Sub: 79वीं संरक्षण समन्वय उप-समिति (पीसीसी) बैठक का कार्यवृत/ Minutes of 79th Protection Coordination Sub-Committee (PCC) Meeting

79th Protection Coordination Sub-Committee Meeting

Date: 19/05/2025 (Monday)

B.8 Grid Disturbance in Tuirial HEP of NEEPCO & Kolasib and Bairabi areas of Mizoram Power System on 07-04-2025:

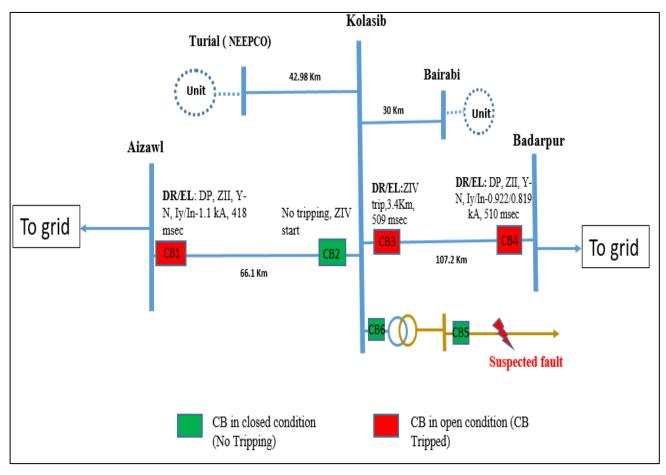
At 03:34 Hrs of 07-04-2025, 132 kV Aizawl-Kolasib and 132kV Badarpur-Kolasib lines tripped. Due to tripping of these elements, Kolasib, Turial and Bairabi areas of Mizoram Power system got isolated from NER grid and collapsed due to no source available in these areas. Load loss of 1 MW occurred.

As per DR analysis, Y-N fault with Iy-922 A, In-819 A initiated at 03:34:05.236 Hrs which was cleared within 510 msec from Badarpur end on operation of DP, ZII (ZIII start) and within 509 msec on ZIV trip from Kolasib end. For 132 kV Aizawl-Kolasib line, fault cleared within 418 msec from Aizawl end on DP, ZII (ZIII start). DR of different time submitted at Kolasib end. There was no tripping from Kolasib end (ZIV start as per EL)

Forum asked P&ED Mizoram to provide relay setting of all the elements connected to Kolasib including downstream elements. Also, Mizoram to conduct relay testing for checking the healthiness for 132 kV Kolasib – Tuirial and 132 kV Kolasib-Bairabi Line. Mizoram informed that relay testing will be done by May-June'25 during internal audit.

Event 1: At 13:58 Hrs of 17th April'25

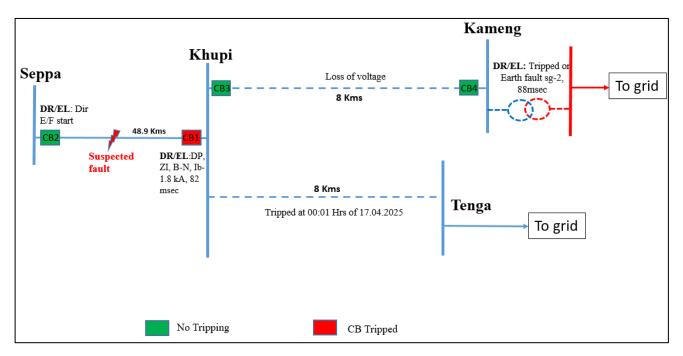
Prior to the event, 132 kV Tenga-Khupi Line tripped at 00:01 Hrs of 17-04-2025. At 13:58 Hrs of 17.04.2025, 400/132 kV ICT at Kameng and 132 kV Khupi-Seppa line tripped resulting in grid disturbance in 132 kV Kameng S/S of NEEPCO, Khupi and Seppa areas of Arunachal Pradesh. Load loss of 1 MW occurred.

As per DR analysis, B-N fault with Ib-1.8 kA initiated at 14:01:22.820 Hrs which was cleared within 82 msec from Khupi end on operation of DP, ZI. Directional E/F started at 13:58:54.479 Hrs and no tripping from Seppa end.

Regarding instantaneous tripping of Kameng ICT on EF, MS NERPC instructed that the settings to be reviewed in a joint meeting between NERPC, NERLDC, DoP AR. Pradsh, NEEPCO and Powegrid.

Event 2: At 18:15 Hrs of 24th April'25

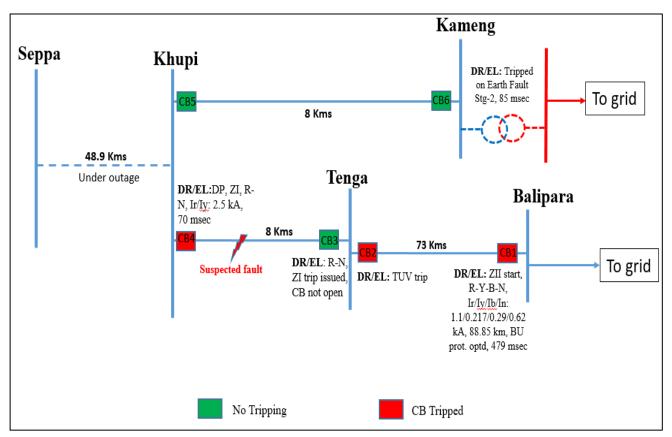
Tenga-Khupi line tripped resulting in grid disturbance in 132 kV Kameng S/S of NEEPCO and Tenga, Khupi and Dikshi areas of Arunachal Pradesh. Load loss of 13 MW occurred.

As per DR analysis, R-N fault (Ir-2.5 kA, In-2.5 kA) initiated at 18:15:35.763 Hrs in 132 kV Tenga-Khupi Line which was cleared within 70 msec from Khupi end on operation of DP, ZI. From Tenga end, DEF start & ZI trip command issued. However, Tenga CB did not open.

B.10 Grid Disturbance in Pasighat and radially connected Napit & Niglok areas of Arunachal Pradesh on 22-04-2025:

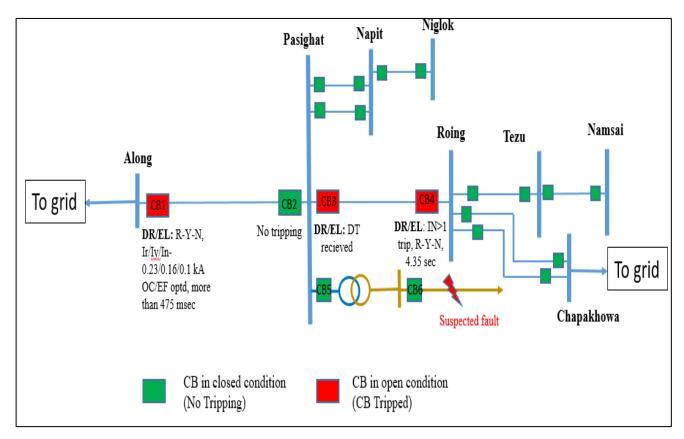
At 00:37 Hrs of 22-04-2025, 132 kV Along-Pasighat & 132 kV Roing - Pasighat lines tripped resulting in grid disturbance in Pasighat and radially connected Napit & Niglok areas of Arunachal Pradesh. Load loss of 22 MW occurred.

As per DR analysis, R-Y-N fault with Ir-237 A, Iy-167 A, In-107 A observed which was cleared in more than 475 msec from Along end on operation of OC/EF protection. No tripping from Pasighat end as per submitted DR. Fault duration recorded at Pasighat EL - 3.726 sec.

Event 1: At 02:43 Hrs of 27-04-2025

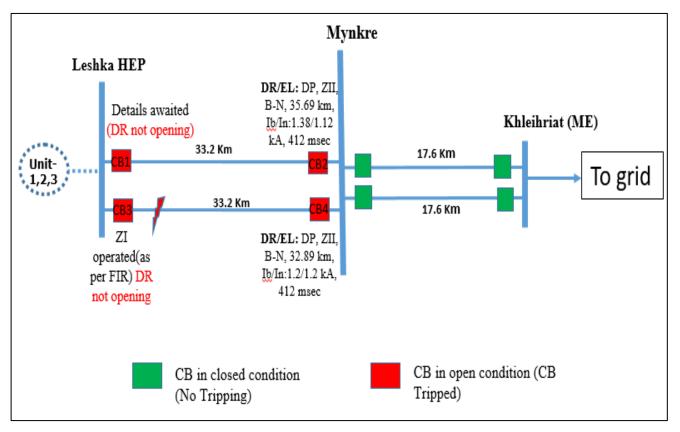
At 02:43 Hrs of 27-04-2025, 132 kV Leshka-Mynkre I & II Lines tripped due to which Leshka Unit-1,2&3 tripped due to loss of evacuation path. Generation loss of 119 MW occurred.

As per DR analysis, solid B-N fault (Ib-1.38 kA, In-1.12 kA) initiated in 132 kV Leshka-Mynkre I & II lines at 02:36:15.155 Hrs which was cleared within 412 msec from Mynkre end on operation of DP, ZII. As per FIR, ZI operated at Leshka end (DR file of Leshka end is not opening)

- Suspected fault in 132 kV Leshka-Mynkre II line as fault distance of 32.89
 Km from Mynkre end (as per EL)
- Leshka end CB failed to isolate the fault resulting in clearing of fault by tripping of healthy 132 kV Leshka-Mynkre I line from remote end on ZII.
- DR file at Leshka end is not opening for both the lines. The same needs attention from MePGCL.
- DR Time drift of 7 min observed at Mynkre end for 132 kV Leshka I & II lines.
- Non-submission of detailed report by MePGCL which is a violation of Clause 37.2 (e) of IEGC regulation 2023.

Event 2: At 07:04 Hrs of 28-04-2025

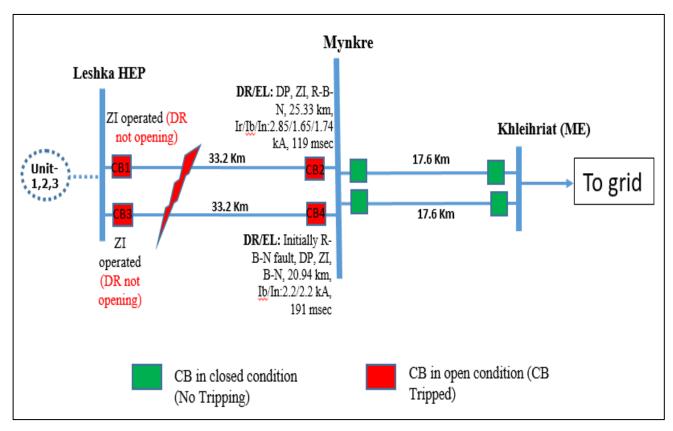
At 07:04 Hrs of 28-04-2025, 132 kV Leshka-Mynkre I & II Lines tripped due to which Leshka HEP of Meghalaya got isolated from grid due to no source available in this area. No generation loss.

As per DR analysis of 132 kV Leshka-Mynkre I line, solid R-B-N fault (Ir-2.85 kA, Ib-1.65 kA, In-1.74 kA) initiated at 06:54:44.787 Hrs which was cleared within 119 msec from Mynkre end on operation of DP, ZI (initially ZII started).

B.12 Grid Disturbance in Dharmanagar area of Tripura Power system on 28-04-2025:

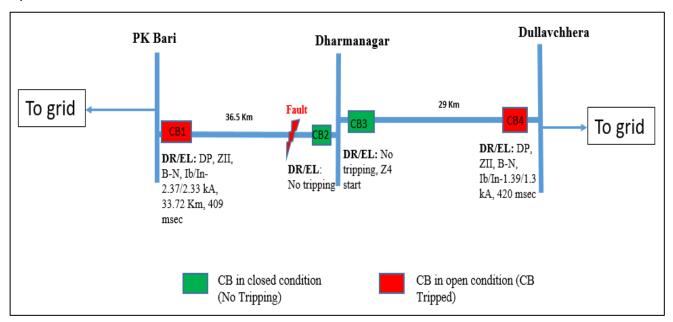
At 09:07 Hrs of 28-04-2025, 132 kV Dharmanagar –Dullavcherra line and 132 kV P K Bari –Dharmanagar line tripped resulting in grid disturbance in Dharmanagar S/S. Load loss of 9 MW occurred.

As per DR analysis, solid B-N fault (Ib-2.37 kA, In-2.33 kA) in 132 kV PK Bari-Dharmanagar Line initiated at 09:03:35.099 Hrs which was cleared within 409 msec from PK Bari end on operation of DP, ZII.

TSECL to share the root cause and provide update on the above mentioned issues.

B.13 <u>Grid disturbance in Churachandpur, Elangkankpokpi, Thanlon, Kakching, Chandel and Morey areas of Manipur and Tamu area Myanmar Power</u> system on 28-04-2025:

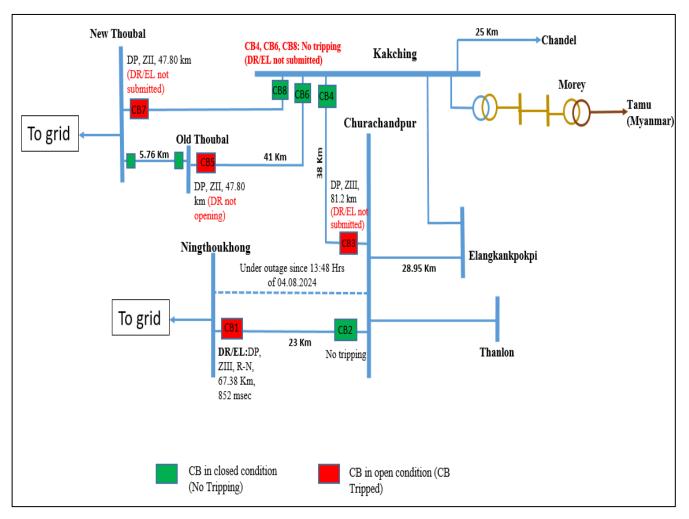
At 13:43 Hrs of 28-04-2025, 132 kV Ningthoukhong-Churachandpur II, 132 kV Old Thoubal-Kakching, 132 kV New Thoubal-Kakching & 132 kV Churachandpur-Kakching Lines tripped. Load loss of 30 MW occurred.

As per DR analysis of 132 kV Ningthoukhong-Churachandpur II Line, R-N fault (Ir-1.26 kA, In-1 kA) initiated at 13:42:32.292 Hrs which was cleared within 852 msec from Ningthoukhong end on operation of DP, ZIII.

MSPCL may share the root cause and provide update on the above mentioned issues.

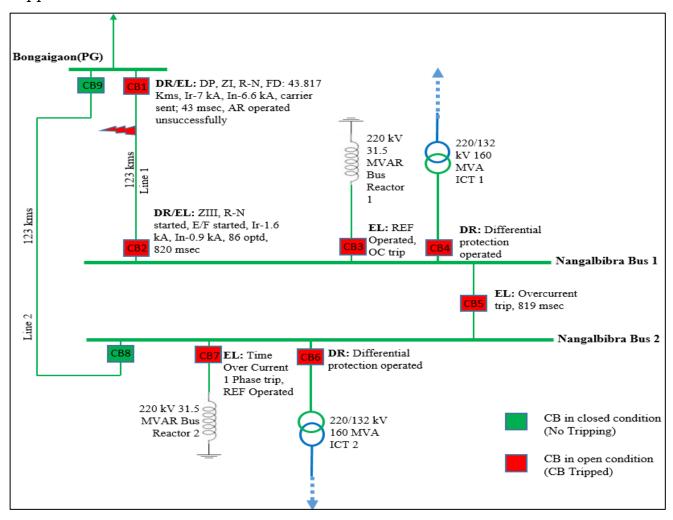
At 20:44 Hrs of 26-04-2025, 220 kV Nangalbibra Bus-I tripped resulting in tripping of all elements connected to Bus-I. Also, 31.5 MVAR B/R-II & 160 MVA ICT-II tripped.

As per DR analysis, R-N fault (Ir-7 kA, In-6.6 kA) initiated at 20:44:43.000 Hrs which was cleared within 43 msec from Bongaigaon end on operation of DP, ZI (Carrier send). AR operated after a dead time of 1 sec but tripped due to persistent fault. At Nangalbibra end, ZIII and E/F started and Carrier was received. However, CB did not trip. After 820 msec, 86 relay operated at Nangalbibra.

- 1. Tripping of Bongaigaon-Nangalbibra line from Nangalbbira end in ZIII settings issue and the same will be revised in coordination with NERPC.
- 2. Tripping of ICTs at Nangalbibra Vector group was incorrectly mapped, so there was differential current for external faults. The matter has been resolved.
- 3. Tripping of Bus reactors stabilizing resistor of the REF failed so it tripped on REF. The matter has been resolved.

Forum instructed Sterlite to review the settings in coordination with NERPC and NERLDC and get protection approval from NERPC at the earliest. Also, Forum suggested NBTL to coordinate O/C setting of Bus coupler with ZIII time delay of Line.

B.15 Multiple tripping on 28-04-2025:

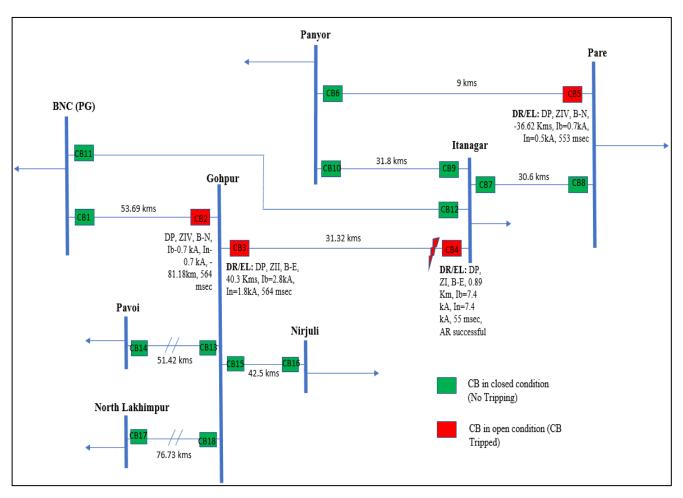
At 10:15 Hrs of 28-04-2025, 132 kV Gohpur-Itanagar, 132 kV Panyor-Pare & 132 kV BNC-Gohpur Lines tripped.

As per DR analysis, B-N fault (Ib-7.4 kA, In-7.4 kA) in 132 kV Gohpur-Itanagar Line initiated at 10:15:15.920 Hrs which was cleared within 55 msec from Itanagar end on operation of DP, ZI (Carrier Send). B-N fault converted into R-Y-N fault (Ir-0.36 kA, Iy-0.56 kA, In-0.9 kA). Fault was cleared within 564 msec from Gohpur end on DP, ZII. Autorecloser operated successfully from Itanagar end.

Regarding tripping of 132 kV Gohpur-Itanagar line at Gohpur end on ZII, forum noted that ZII should have operated in 350 msec and carrier aided tripping should have occurred. AEGCL informed that, regarding carrier aided protection, testing for carrier will be conducted during May'25 and the time delay setting will be revised shortly.

Regarding tripping of 132 kV Gohpur-BNC line at Gohpur on ZIV, Forum requested AEGCL to revise the reach of ZIV as it should not be more than 50% of the shortest line as per NERPC protection protocol.

Regarding tripping at Pare end, NEEPCO acknowledged that there is reach issue of ZIV and stated that the same will be revised shortly.

C.3 Grid Disturbance in Loktak HEP of NHPC & Rengpang area of Manipur Power system on 24-03-2025

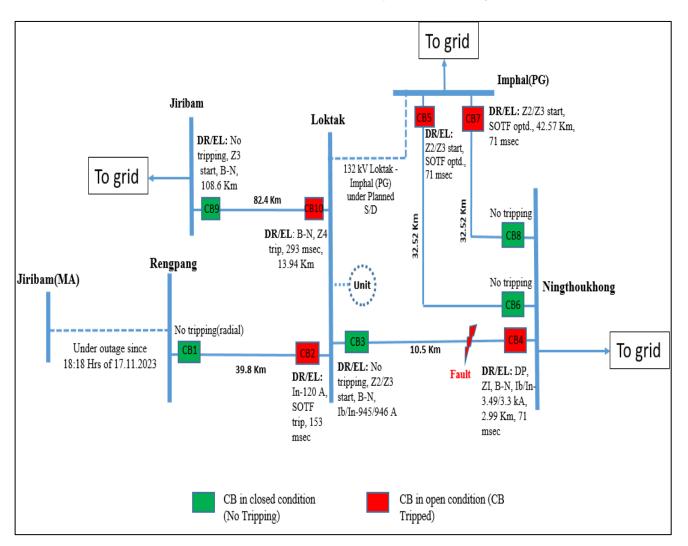
At 11:38 Hrs of 24.03.2025, 132 kV Loktak-Jiribam, 132 kV Loktak-Ningthoukhong and 132 kV Loktak-Rengpang lines tripped resulting in blackout of Loktak HEP & Rengpang. Load loss of 1 MW occurred.

As per DR analysis, resistive B-N fault (Ib-3.49 kA, In-3.3 kA) in 132 kV Loktak-Ningthoukhong line at a distance of 2.99 Km initiated at 11:38:07.129 Hrs which was cleared within 71 msec from Ningthoukhong end on operation of DP, ZI. ZII started at Loktak end (no tripping) and fault current disappeared within 293 msec. 132 kV Loktak-Jiribam line tripped from Loktak end on Z4 within 293 msec (FD: 13.94 Km). Z3 start from Jiribam end and no tripping.

- Implement PLCC and Line differential protection on the Loktak Ningthounkong (10.5 Km) line – Going to purchase PLCC or may be DTPC. LDR matter has been escalated to higher authority.
- 2. Review and rectify the Z4 timing and reach at Loktak end for the Jiribam lineto be done within a week
- 3. Rectify the SOTF issue at Loktak end for Rengpang line. to be done within a week

C.4 Grid disturbance in 132 kV Umiam S/S of Meghalaya Power system on 01-04-2025:

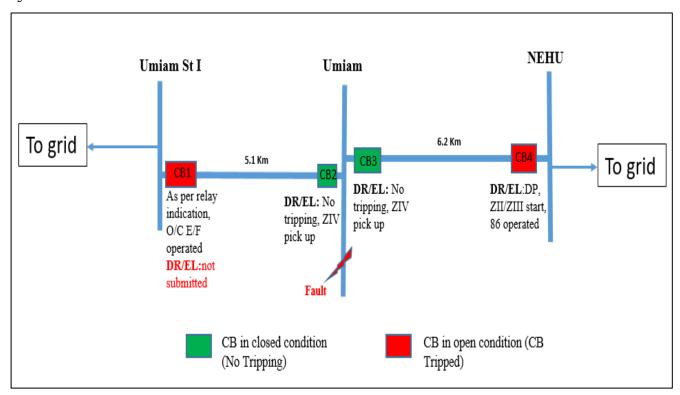
At 01:55 Hrs of 01-04-2025, 132 kV Umiam-Umiam Stg I and 132 kV NEHU-Umiam Lines tripped resulting in blackout of 132 kV Umiam S/S of Meghalaya Power system.

As per DR analysis, R-N fault (Ir-3.1 kA, In-2.9 kA) initiated at 01:55:31.117 Hrs which was cleared within 121 msec from NEHU end. ZII/ZIII start and 86 operated at 01:55:31.202 Hrs. Z4 pickup at Umiam end (no tripping).

Forum suggested MePGCL that High set to be disabled at Umiam St I.

Forum requested MePGCL to install the Distance protection at Umiam stg I at the earliest and install OPGW on the lines and enable the LDP.
